ADDENDUM NO. 2

Project Name: **Roseland Elevated Storage Tank Change and Pump Station**

Bid Number: 2019068

This addendum is being released to answer questions received to date.

SHEET NUMBER
E-2

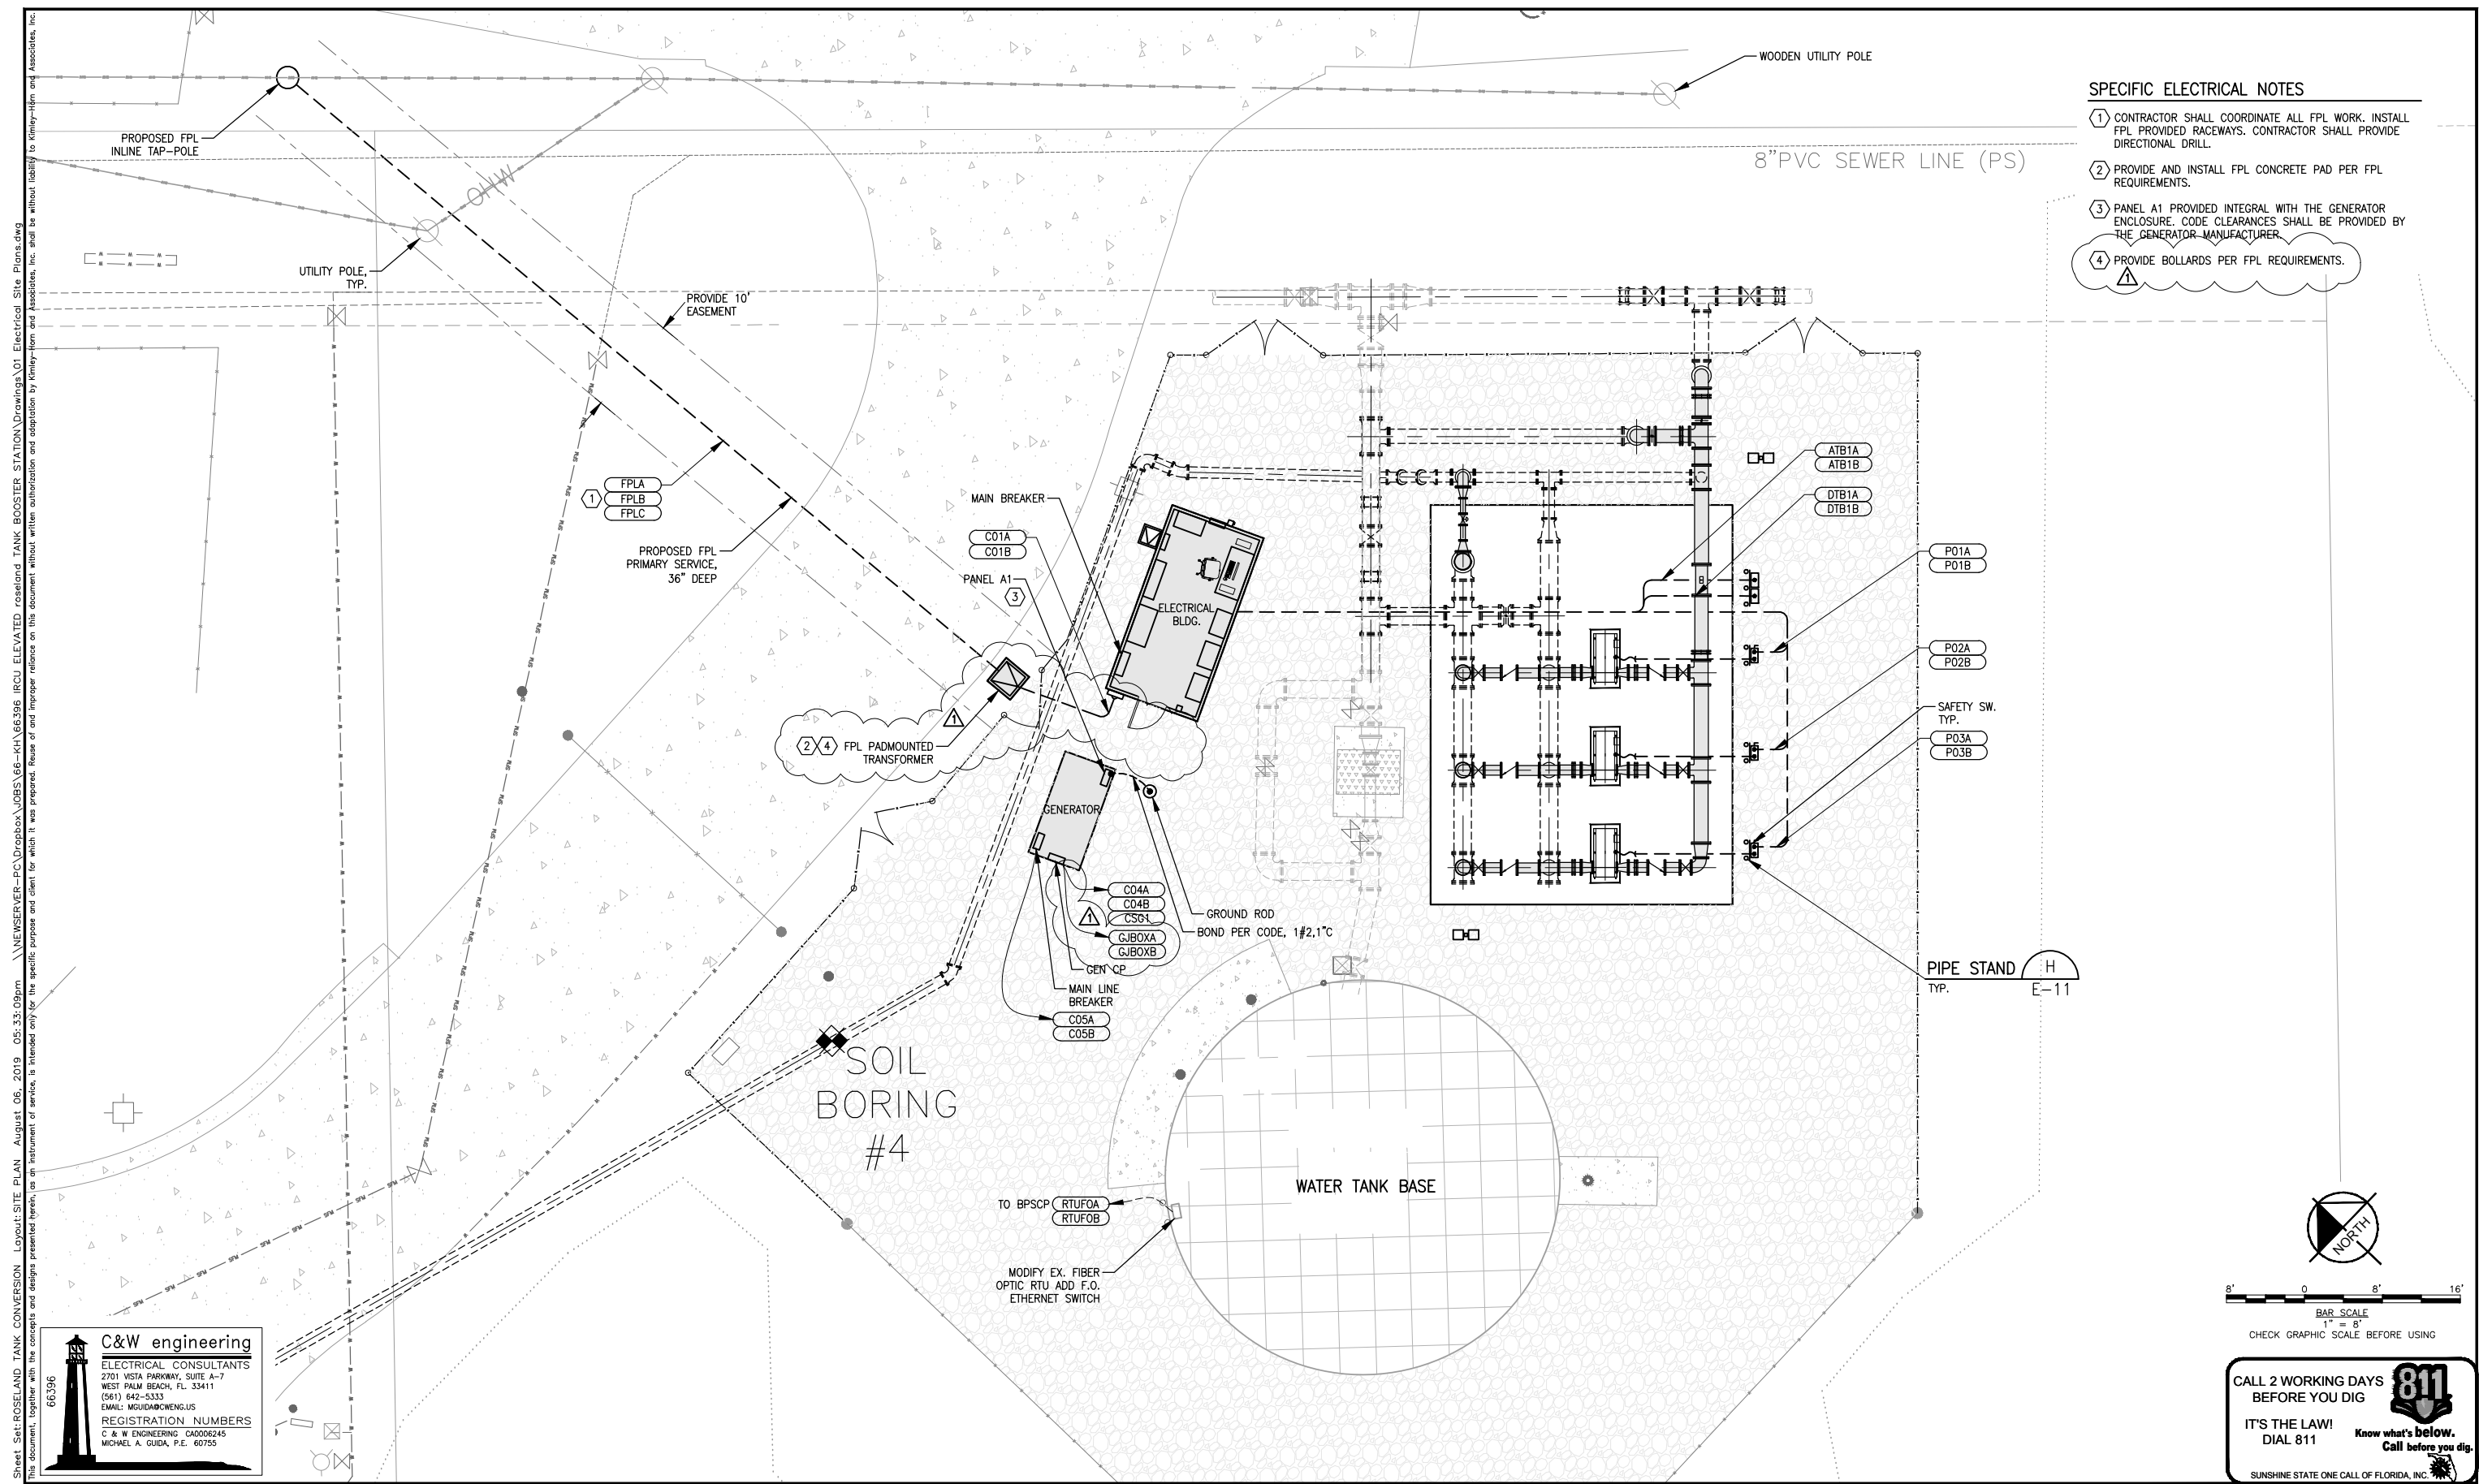
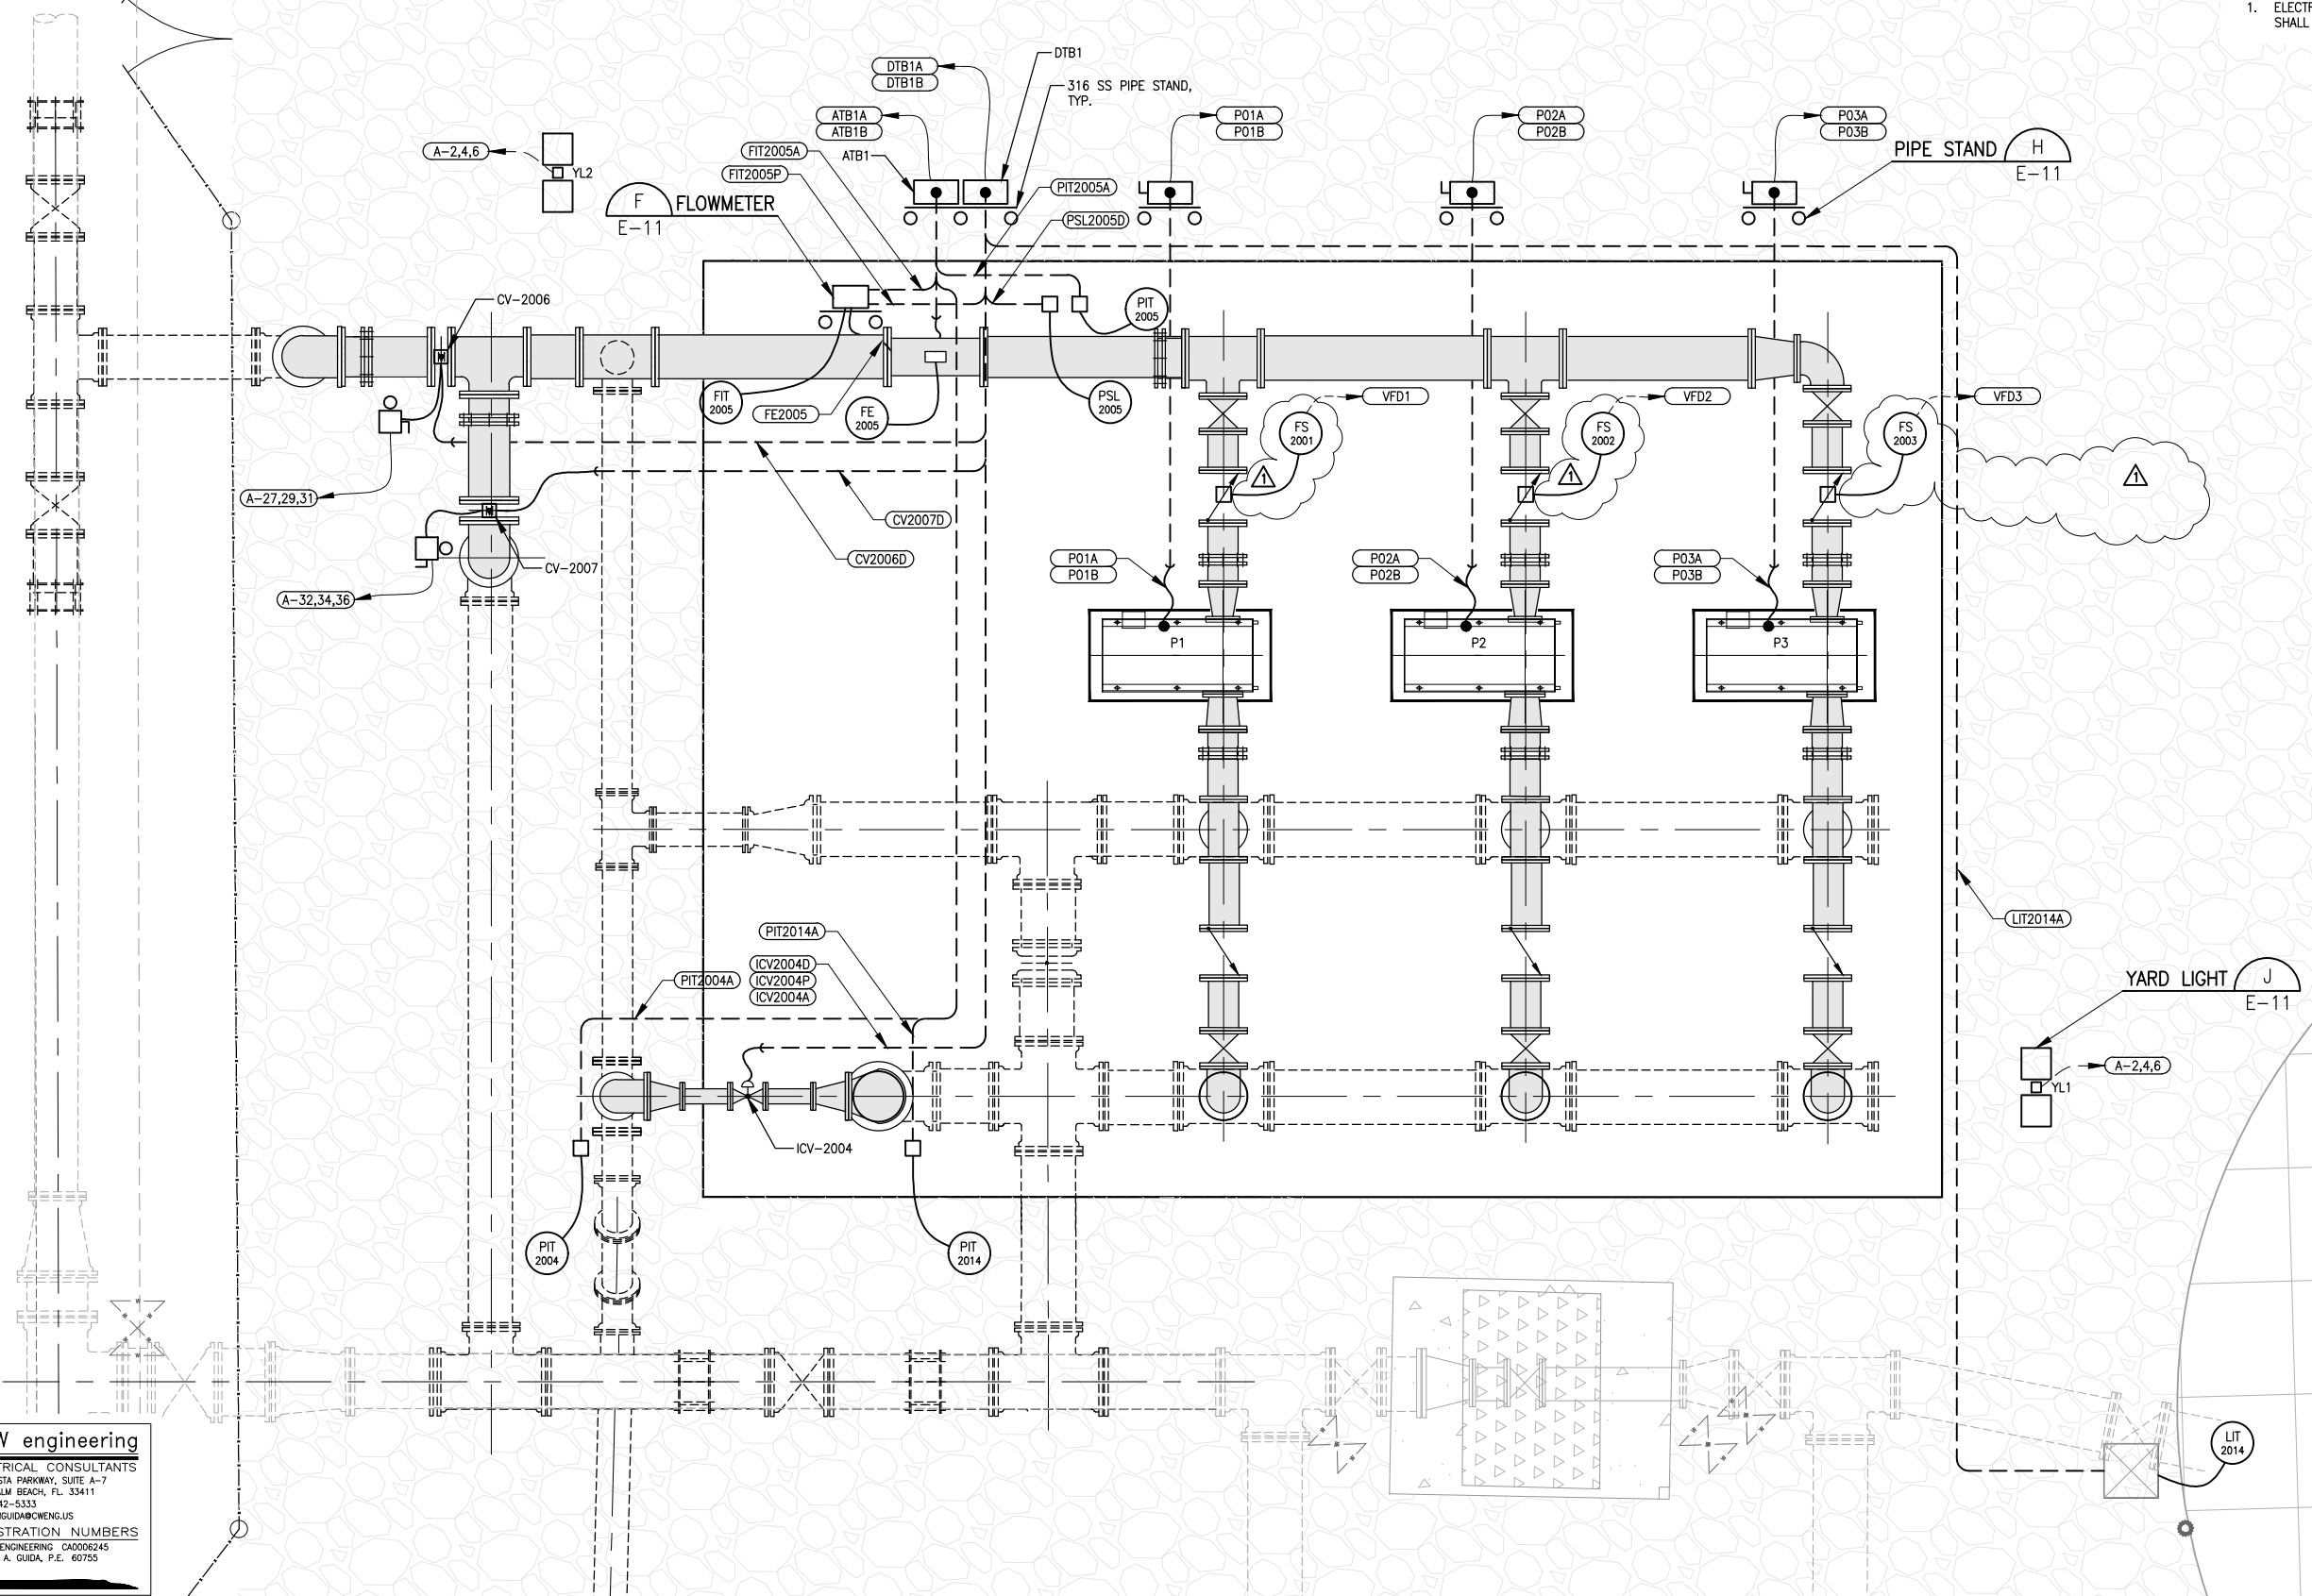
9. **Question:** Is the owner providing an allowance for relocation of the FPL: overhead wire protection, directional bore materials, raceways and wires, Transformer and transformer pad, and any incidental FPL work

21. **Question:** Will Bollards be required around the 480 V Pad Mounted Transformer?

No. Refer Drawing E-2 for the Contractor's scope of work.

Yes, per FPL requirements.

SHEET NUMBER
E-3

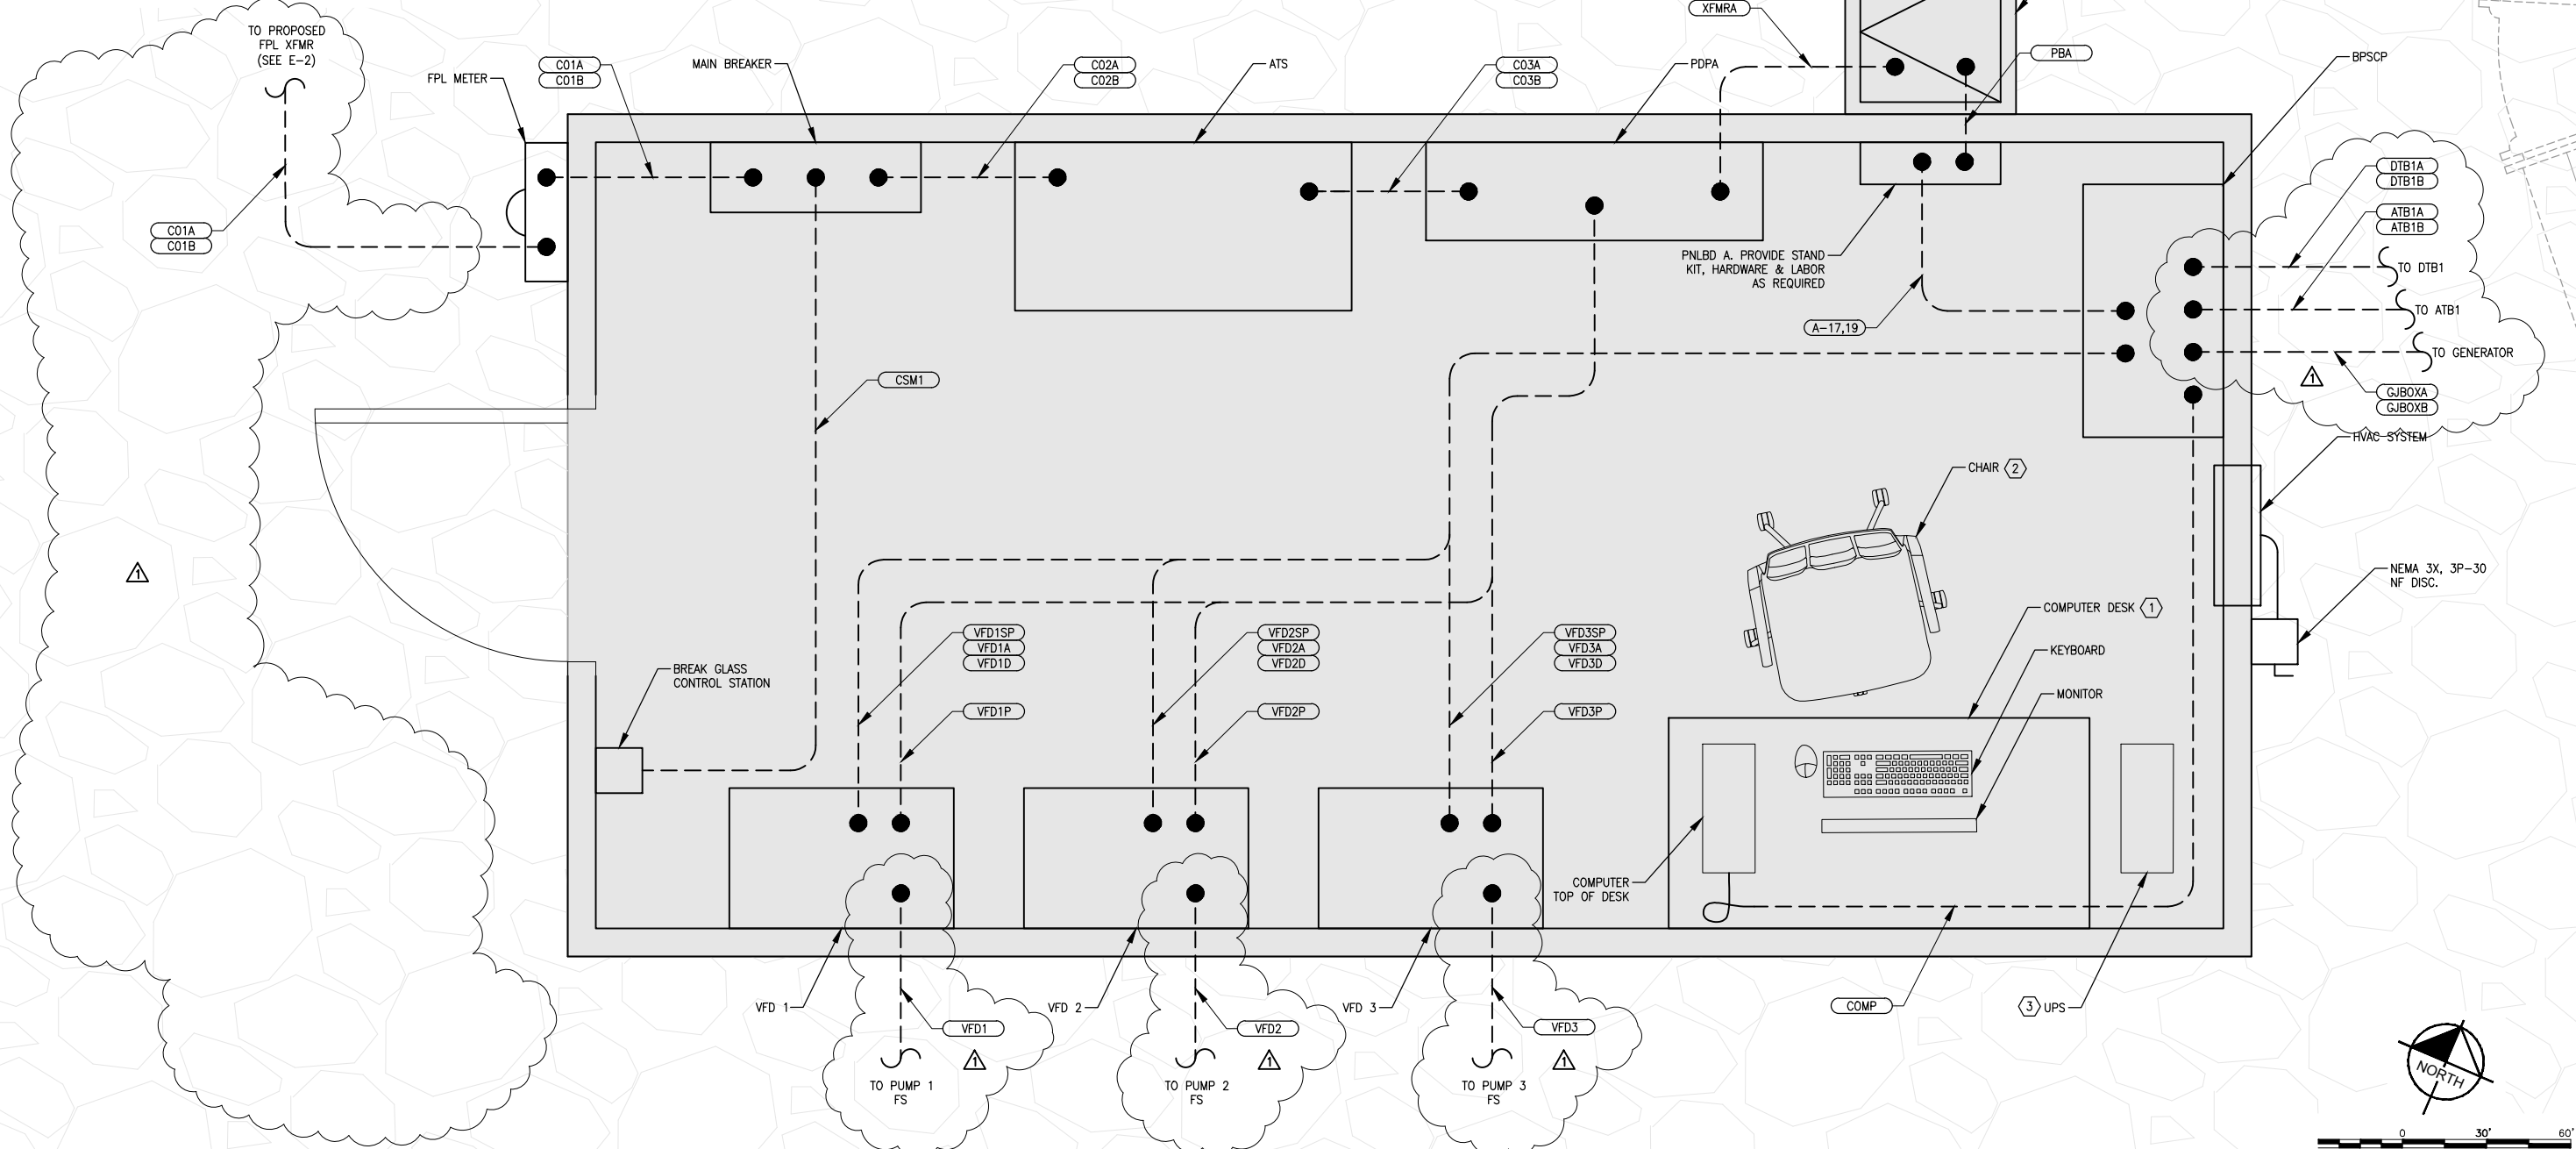
4. **Question:** Limit Switches cannot be installed on Globe Check Valves as shown on E-3. Can the Globe Check Valves be changed to Lever & Weight Style per IRC Spec which are compatible with Limit Switches?

No. Provide flow switches in accordance with P&ID Drawing M-1 and Specification Section 13441, Paragraph 2.05.
